MEETING MINUTES  
FEBRUARY 14-15, 1985 MEETING OF THE  
COMBINED SUBCOMMITTEE ON GESSAR-II AND  
RELIABILITY AND PROBABILISTIC ASSESSMENT

The ACRS Subcommittees on GESSAR-II and Reliability and Probabilistic Assessment met on February 14-15, 1985 at the Best Western Airport Park Hotel in Englewood, CA. The purpose of this meeting was to continue the Subcommittee review of GESSAR-II for a Final Design Approval applicable to future plants. The principle topic in these discussions was seismic risk. The Subcommittees heard presentations from representatives of NRR, BNL, Jack R. Benjamin and Associates, and General Electric Company. The meeting was begin at 8:30 am on February 14, adjourned at 6:30 pm on February 14, reconvened at 8:30 am on February 15, and adjourned at 12:00 am on February 15. Parts of the meeting were closed for the discussion of proprietary material. The principle attendees were:

GESSAR II Seismic Hazard Curve Compared to Hazard Curves from other Studies.

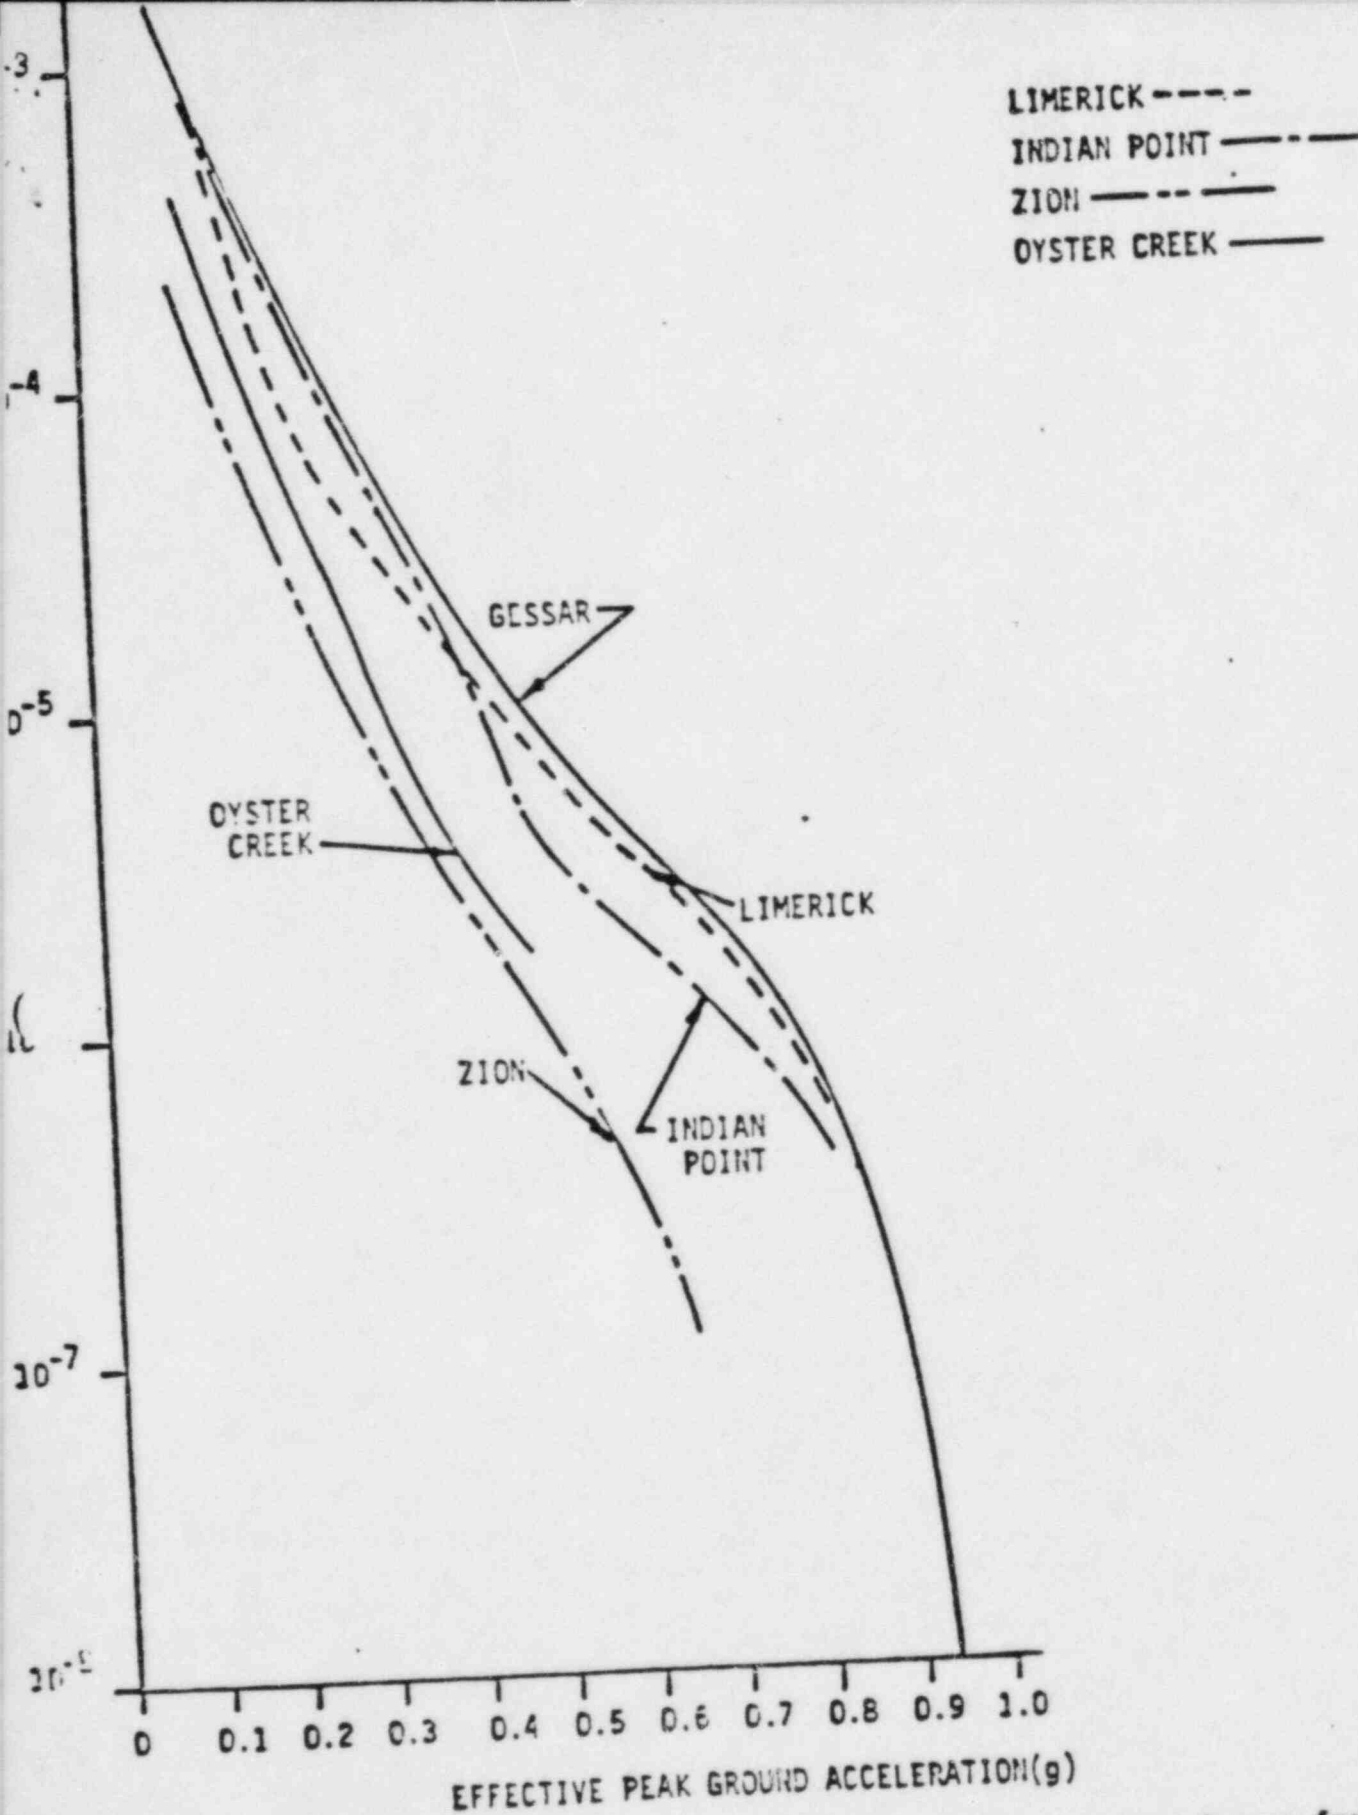
3. General Electric described the methodology which was used in their seismic risk evaluation. A seismic hazard curve was developed with the intent of encompassing most of the possible sites in the

Eastern United States. This hazard curve is shown on Figure 1 and compared to seismic hazard curves used in other industry PRA's. Figure 2 contains a more complete collection of seismic hazard curves, including a number which were generated in recent LLNL evaluation. The curves generally represent best estimates accompanied by large uncertainties and are generally based on surveys of expert opinion.
